BEFORE THE NORTH CAROLINA UTILITIES COMMISSION

DOCKET No. E-100, SUB 158

**Biennial Determination of Avoided Cost Rates
for Electric Utility Purchases from Qualifying
Facilities – 2018**

**DIRECT TESTIMONY OF
BRENDAN KIRBY, P.E. ON
BEHALF OF SOUTHERN
ALLIANCE FOR
CLEAN ENERGY**

Gross Load Volatility (03/25/2019)

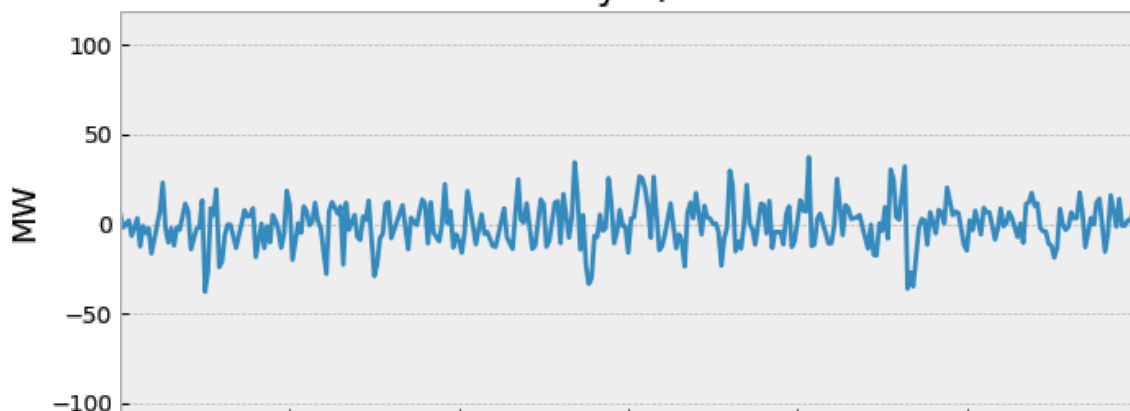
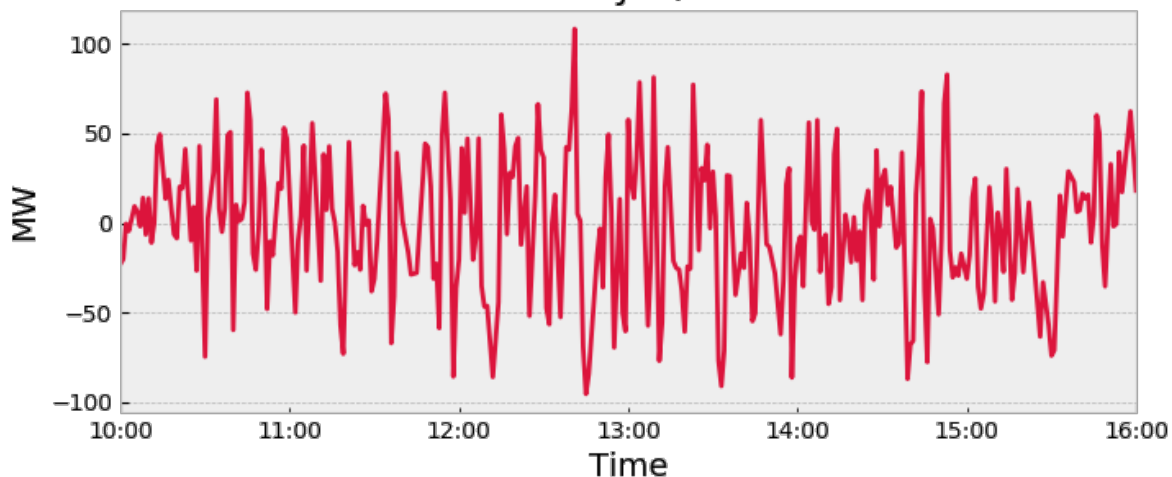
5 **Q. Page 35 of Mr. Snider's May 21, 2019 Direct Testimony includes a Figure 5,**
6 **meant to illustrate an increase in volatility with solar generation currently**
7 **operating on the DEP power system relative to a no-solar scenario. Please**
8 **respond to this figure.**

9 **A.** I would like to make two important points regarding this figure. First, as
10 discussed above, NERC mandatory reliability standards do not require
11 instantaneous balancing of all deviations, so finding a single 2-minute interval
12 with a 65 MW increase in deviation does not equate to a NERC requirement of an
13 additional 65 MW of reserves.¹² Second, Figure 5 shows the results for March 10,
14 2019, the most variable day of the 10-day sample provided. The other nine days
15 have single point excursions that range from 7 MW to 62 MW (averaging 35
16 MW) higher with solar than without.

17 In any case, Figure 5 does not demonstrate that the average deviation is 35
18 MW greater with solar than without. To the contrary, it shows that the single
19 worst daily 2-minute deviation in this sample of ten days is, on average, a mere 35
20 MW greater with solar than without. And again, NERC does not require

1 balancing each 2-minute deviation. Therefore, Figure 5 seems to prove that the
2 *Ancillary Service Study* significantly overstates the added reserve requirements
3 that increased solar penetration imposes on the Companies' balancing areas.
